Modification Recommended Service Note

N8920A - Autoranging System DC Power Supply, 80V, 170A, 5000W, 208 VAC

Serial Numbers: DE14290000 - DE15369999 without manufacturing ID Version "B"

5) SMT resistors R93/94 are located in red circle shown below:

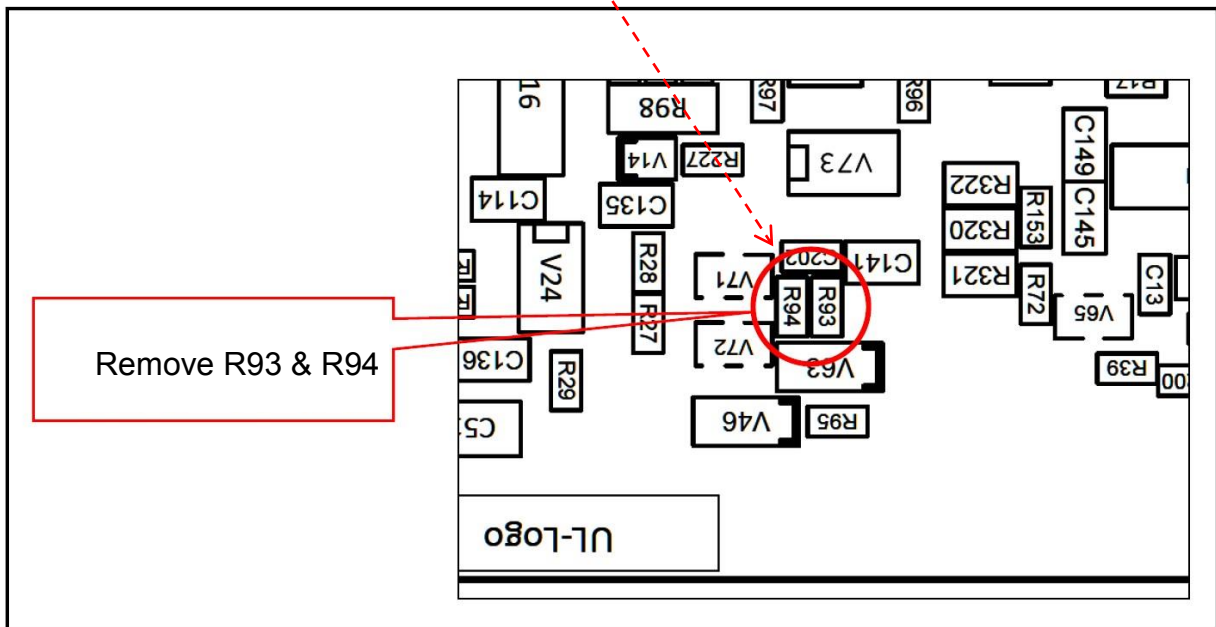
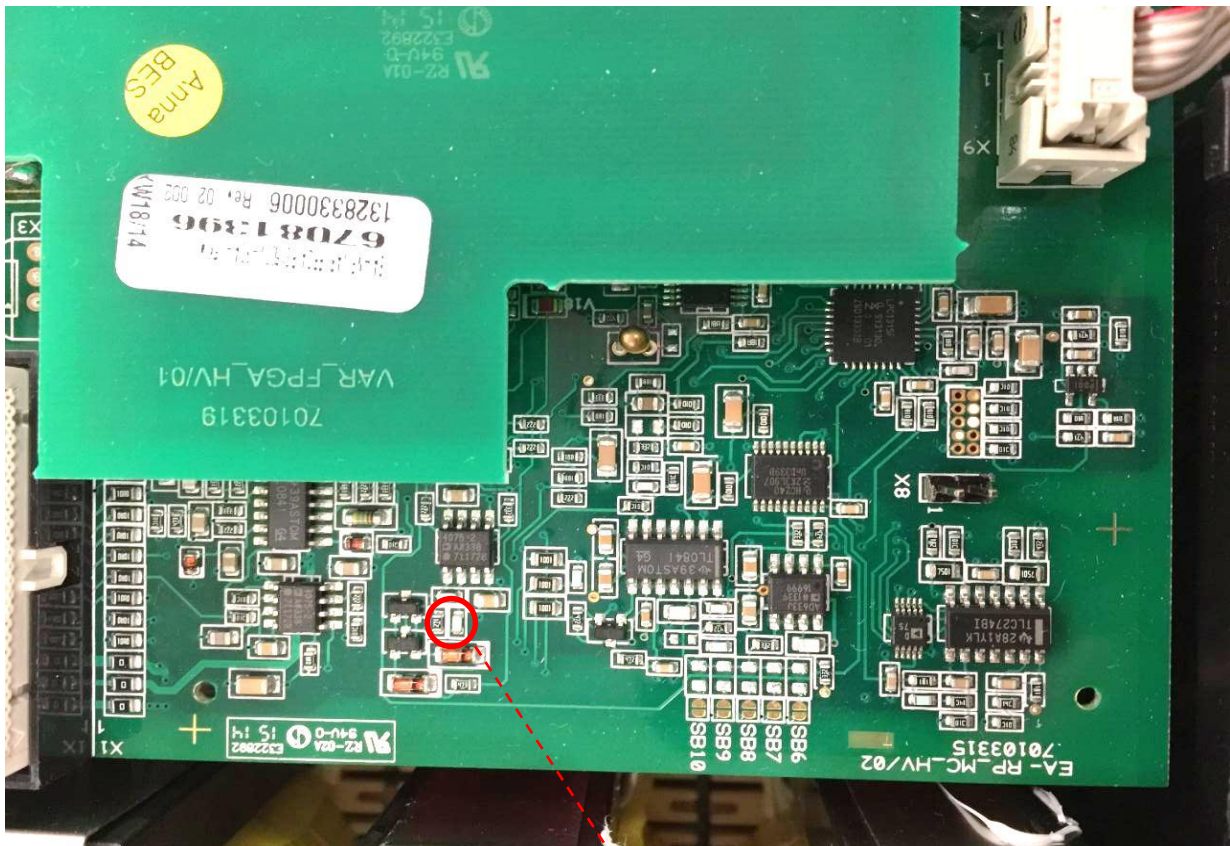
- 1) Remove acMains cable from power source.
- 2) Wait 5 minutes
- 3) Remove top cover from instrument.
- 4) In the 5kW units (viewed from the front of the unit), a small SMT assembly located at the right-rear of instrument will be readily visible (see below):

In the 10kW & 15kW units; although found in the same location, a black plastic cover will have to be removed to gain visibility and access to the SMT assembly. Plastic cover snaps-on and can be removed with a small screwdriver.

Removal of two (2) surface mount resistors, R93 and R94, will correct this problem:

Resistors R93 and R94 must be removed, no replacement parts are required for modification.

Suffix "B" added

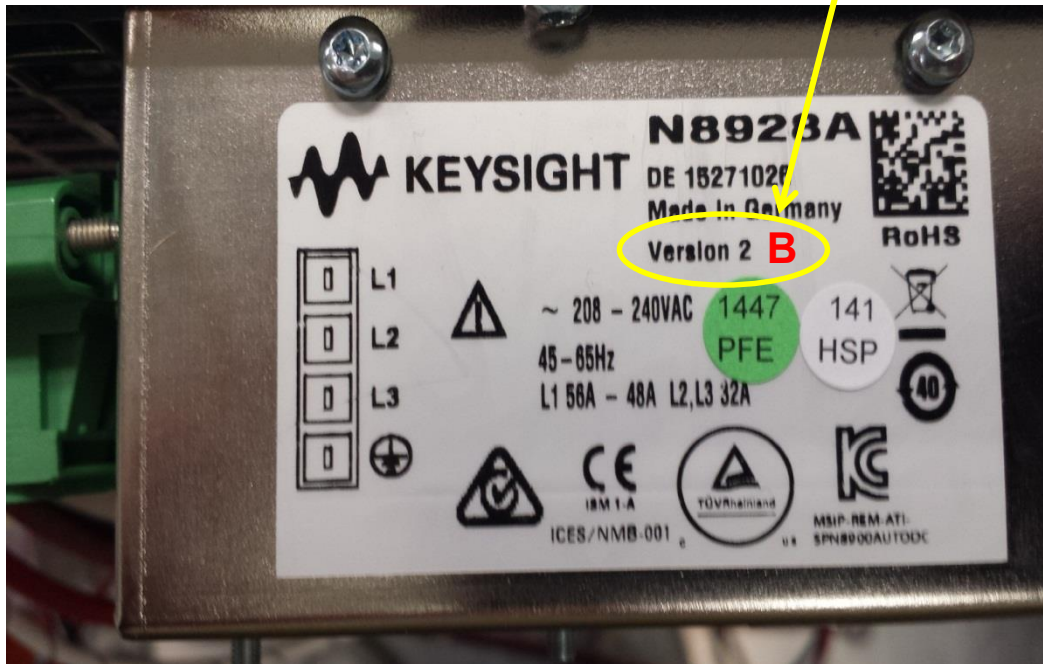
7) On the acMains label, on the rear of the instrument; use an indelible marker, to add the suffix letter "B" after the Version ID. This will assist in the tracking of modified instruments.
